**1429 ECK ROAD OUTDOOR STORAGE**  
**MAJOR PLAN 2022-109**  
**ATTACHMENTS**

**TO: PLANNING COMMISSION**  
**FROM: GREGG R. ADAMS, PLANNER**  
**SUBJECT: 1429 ECK ROAD OUTDOOR STORAGE**  
**MAJOR PLAN 2022-109**  
**REQUEST FOR PRELIMINARY/FINAL PLAN REVIEW**

Re: South Whitehall Township  
1429 Eck Road Outdoor  
Storage  
Major Plan #2022-109  
Preliminary/Final Plan Review

**PRELIMINARY/FINAL LIGHTING PLAN**

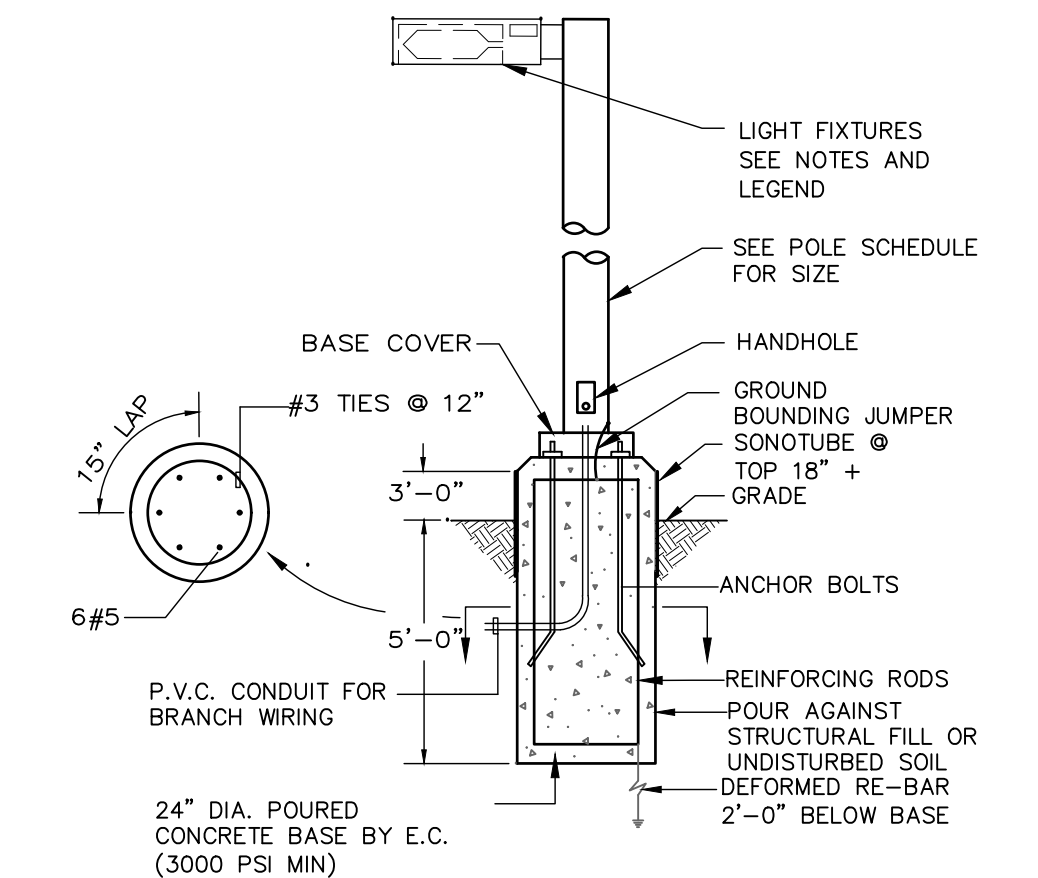
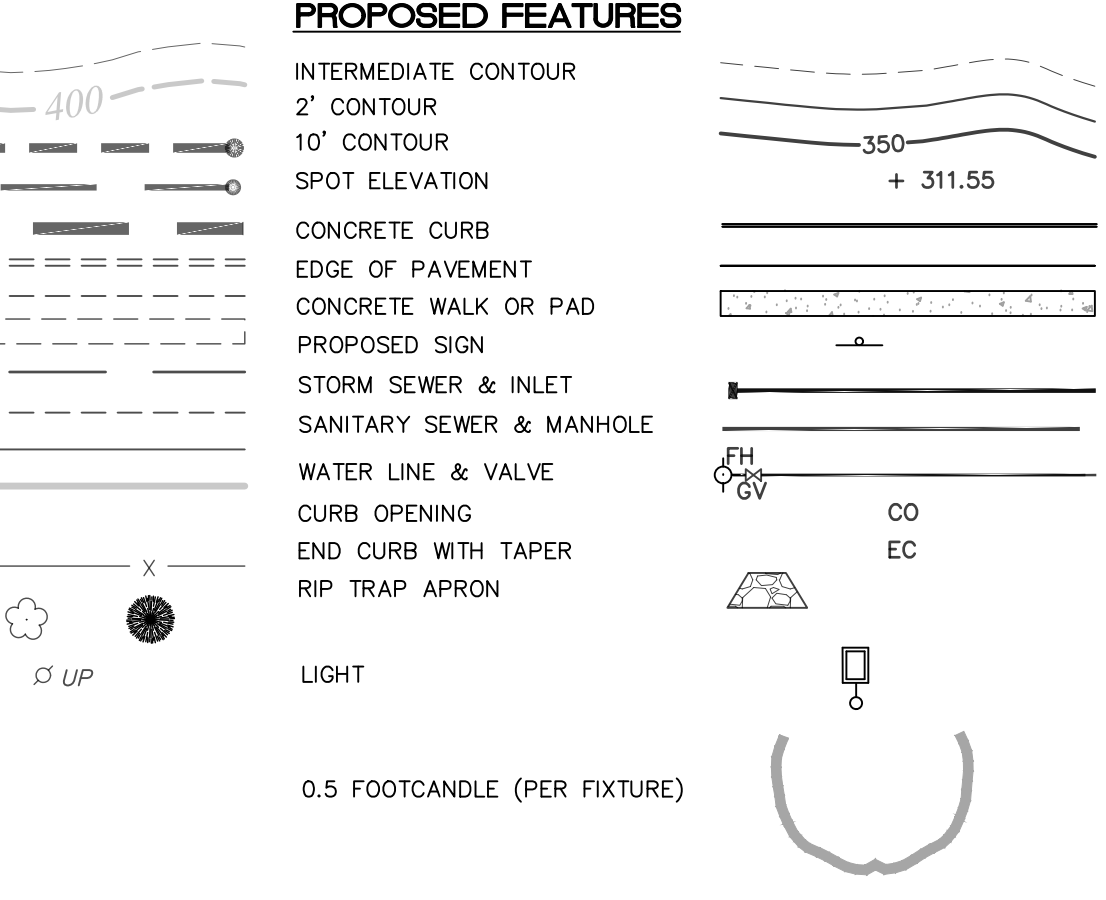
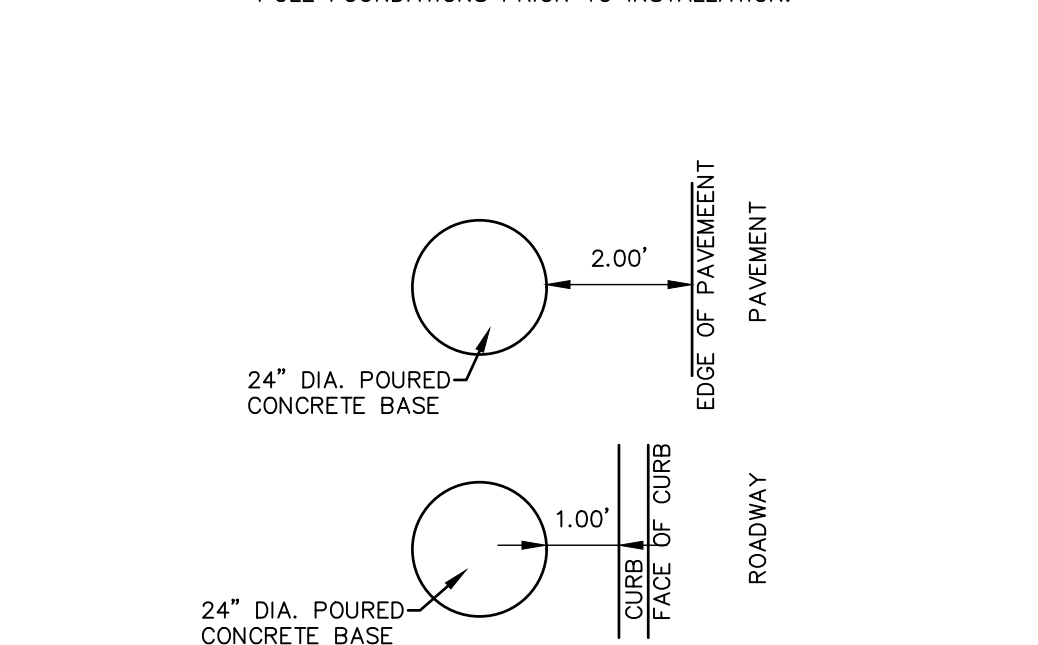
- Sheet LD-8 submitted on May 15,2023 and last revised on December 4, 2023

The plan as submitted does not contain enough information to determine conformance to the latest Township Ordinance, namely:

- (1) There is no manufacturer's cut sheet attached to determine conformance with the latest township ordinance requiring that fixture are full cut-off
- (2) There is no manufacturer's cut sheet or information regarding the poles being used to determine conformance with EPA requirements for wind ratings
